C14.
Communication
CW(PM) – November 1, 2023
Item No. 4

Re: Draft 2 Weston 7 Secondary Plan (File No. 26.2)
Committee of the Whole Public Meeting – Item 4
3850 Highway 7, Woodbridge Canadian Tire Plaza
CT REIT

**Re: Draft 1 Weston 7 Secondary Plan
3850 Highway 7, Woodbridge Canadian Tire Plaza
CT REIT**

Figure 3 – Site Plan Overlay on Weston 7 Secondary Plan Schedule 4 – Transportation System

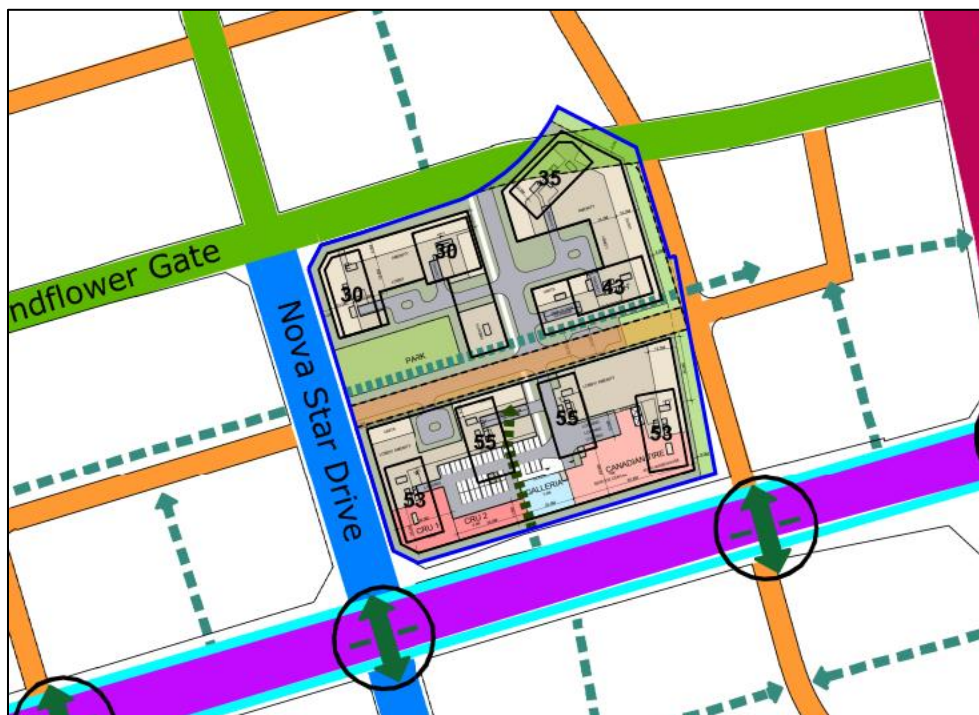
- The draft Transportation System schedule has been updated to address the inconsistencies between the TMP and the first draft of the Weston SP. However, the draft schedules still propose to extend a portion of Windflower Gate east through a portion of the subject property. We would like to reiterate our comment in the previously submitted comment letter and request consideration that Windflower Gate be realigned in a way that avoids or minimizes impact to the existing north-east corner of the subject property.

- Further to the general comment provided above regarding the integration of the Road Network and Active Transportation Network, we believe that the proposed north-south Active Transportation Link bisecting the subject property from Highway 7 should be relocated on the map or subject to policies that provide flexibility in the location of the Active Transportation Link without requiring an amendment to the SP. Furthermore, as per Section 7.1.3, where a development block exceeds 180 metres on any public road, it shall be provided with a mid-block Active Transportation Link. It is noted that the frontage of the subject property is approximately 160 metres, which is below the 180 metres requirement. We request that the SP provide a policy that allows for flexibility in the location of the Active Transportation Link on the subject property.

Figure 2 – Site Plan Overlay on Weston 7 Secondary Plan Schedule 4 – Transportation System

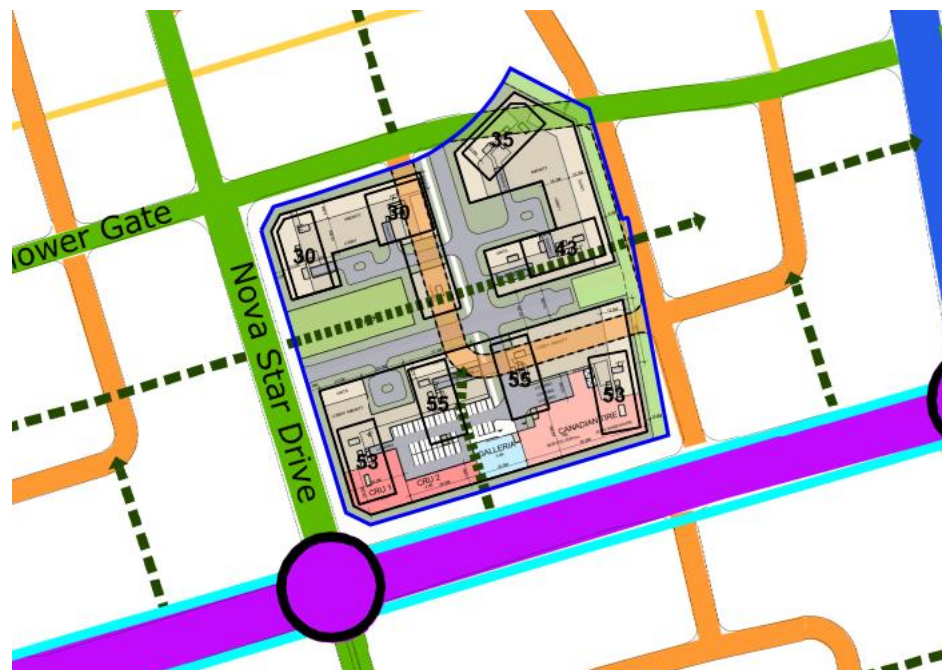
According to the proposed draft schedules, the east-west portion of Windflower Gate is proposed to be extended east through a portion of the subject property and the portion of Windflower Gate is proposed to be extended south along the eastern boundary of the subject property. The proposed east-west Windflower Gate extension appears to impact the north-east corner of the subject property, ultimately impacting the net developable area of the site (Figure 2).

Based on proposed draft Schedule 4 (Transportation System), we are of the opinion that Windflower Gate, identified as a Collector Road, could still extend east to Weston Road, but should be realigned in a way that avoids or minimizes impact to the existing north-east corner of the subject property. While we are supportive that the Weston 7 SP includes proposed policy that permits minor adjustments to the approximate location of roads, provided that the general intent of the Plan is preserved, we request that the proposed Collector Road on Schedule 4 (Transportation System) be modified to address our above-noted concern regarding the current lot configuration.
